**IN THE MATTER OF** Proposed Plan Change E: Roxburgh Residential  
Area to the Palmerston North City Council  
District Plan

**SUPPLEMENTARY STATEMENT OF EVIDENCE OF EAMON MICHAEL GUTHRIE AND ANDREA  
MICHELLE HARRIS ON BEHALF OF PALMERSTON NORTH CITY COUNCIL**

**Dated: 25 JUNE 2025**

<https://www.timeanddate.com/sun/@-40.36221,175.64531?month=6&year=2025>

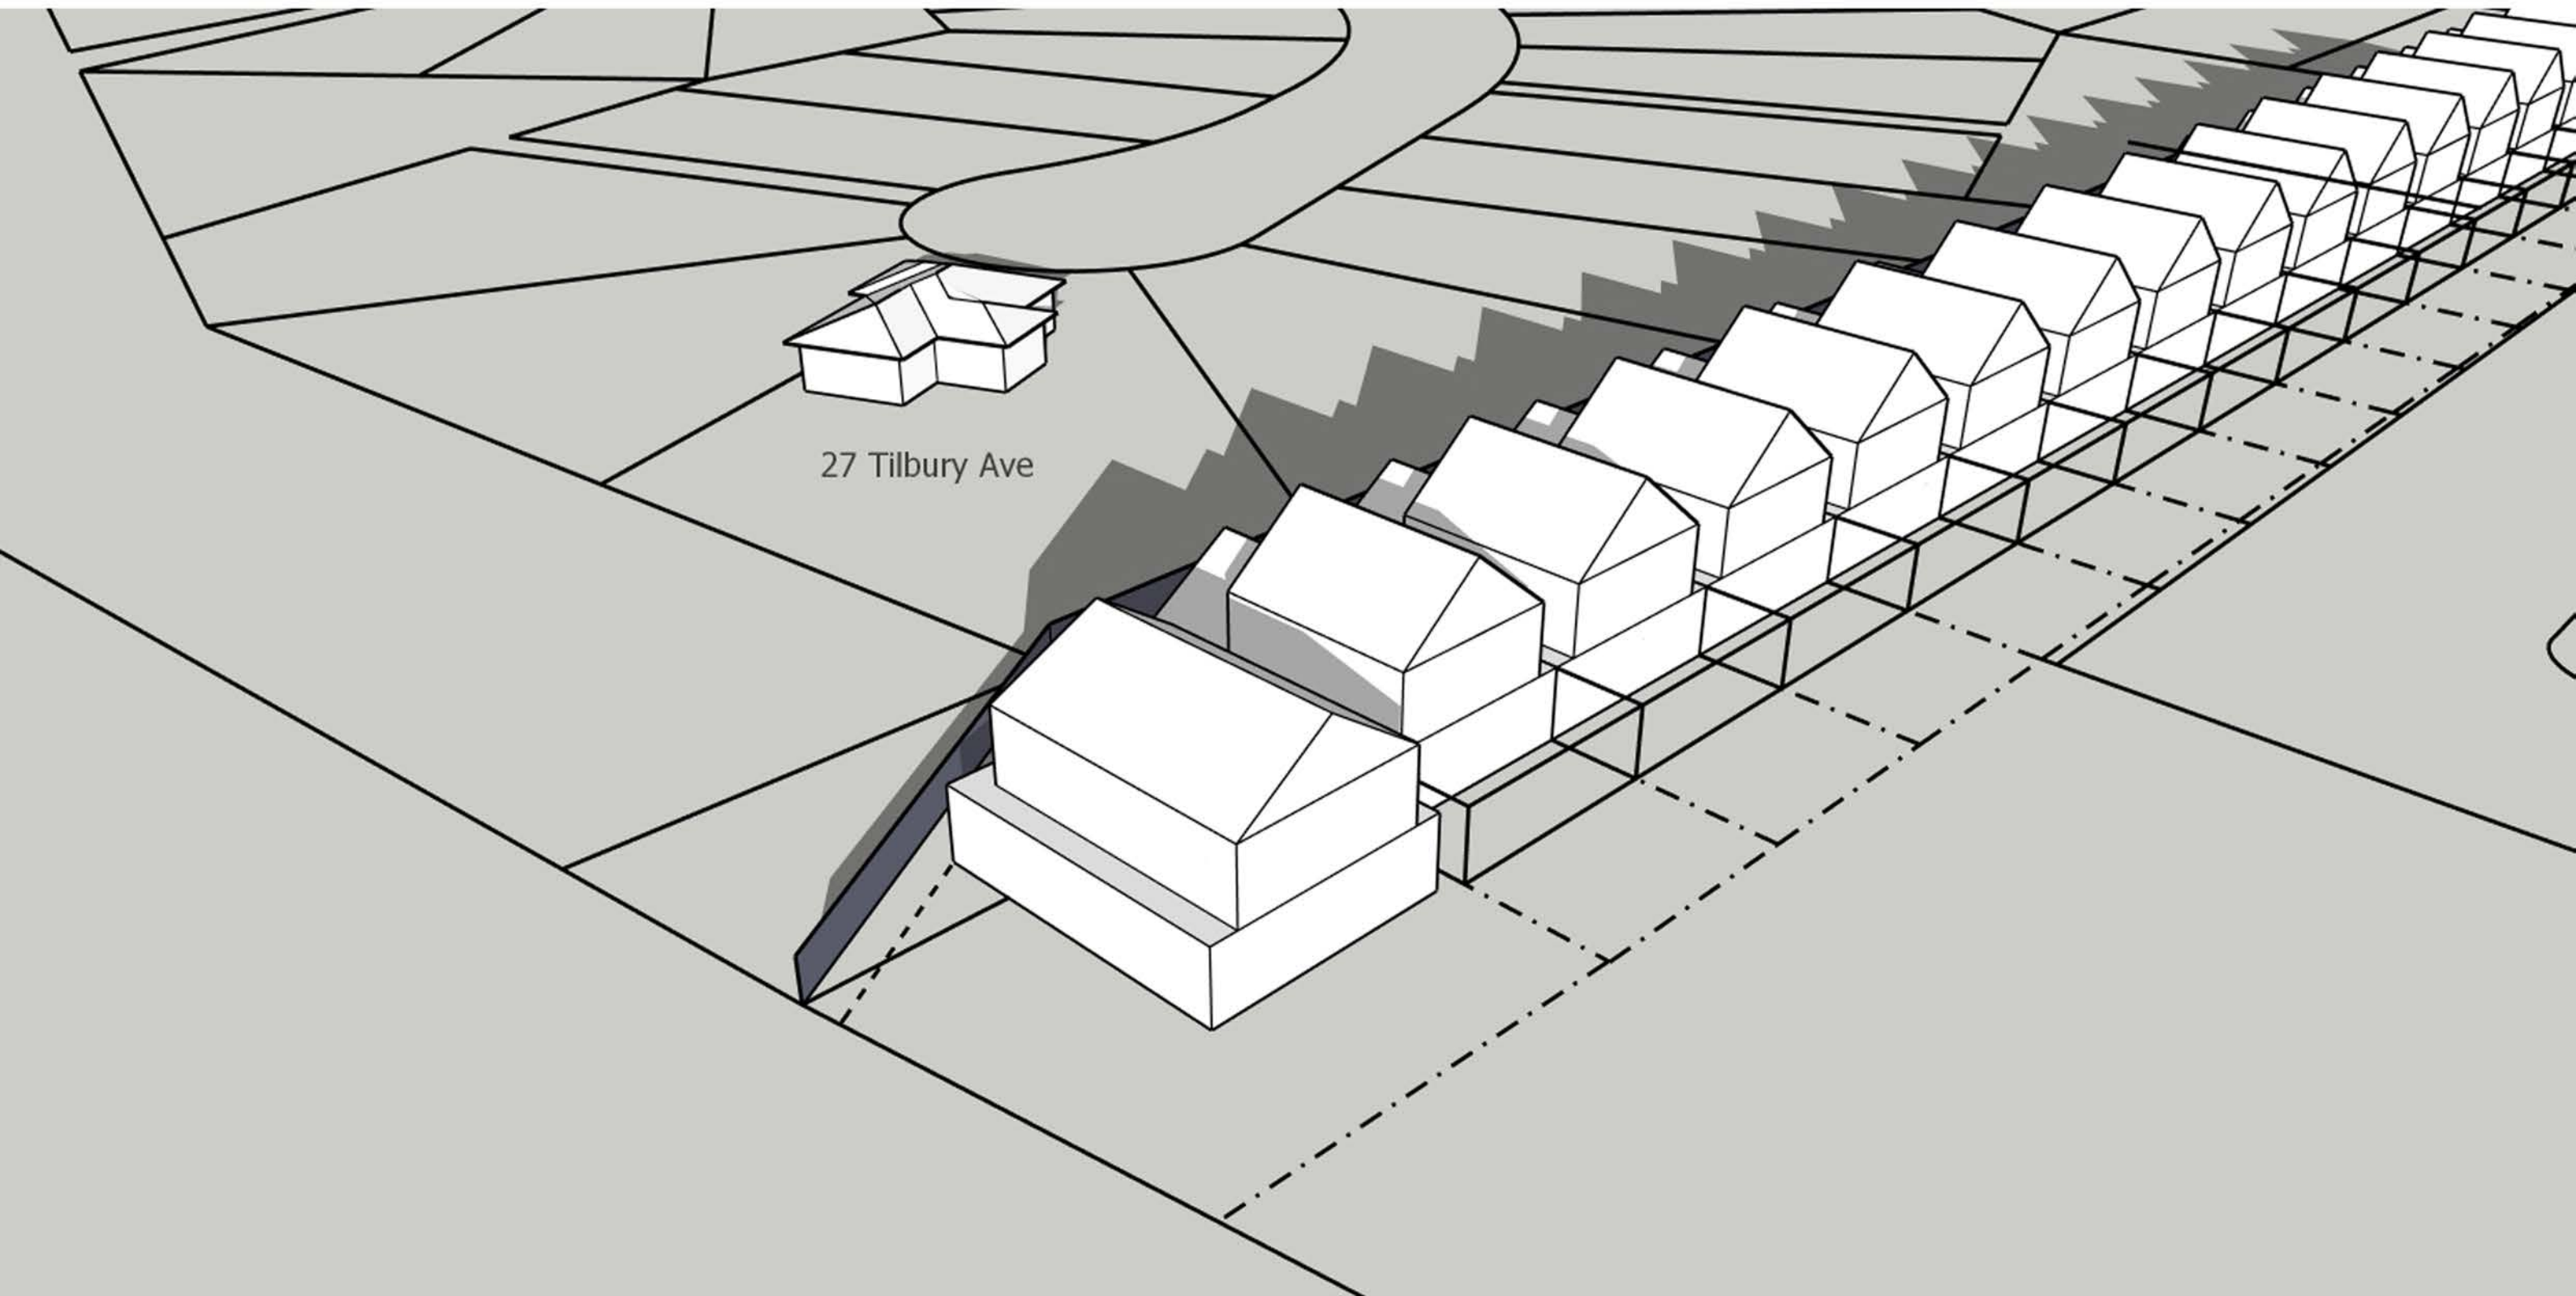
[43] In support of this approach, attached at **Attachment B**, are updated renders showing the potential shading effects on Tilbury Avenue, as a result of the revised performance standard. These have been prepared by Mr Charnley and are based on what the shading and building bulk effects may be during winter solstice along the Tilbury Avenue boundary.

[44] We consider that a separation distance of 1.5m plus a single-storey height limit within rear third of a lot is appropriate. The revised performance standard will provide a reasonable degree of privacy and bulk protections along the Tilbury Avenue interface, as was sought originally from Ms Watson. Figure 1 in the Residential zone shows a height recession plan already taking into account the elements of the proposed
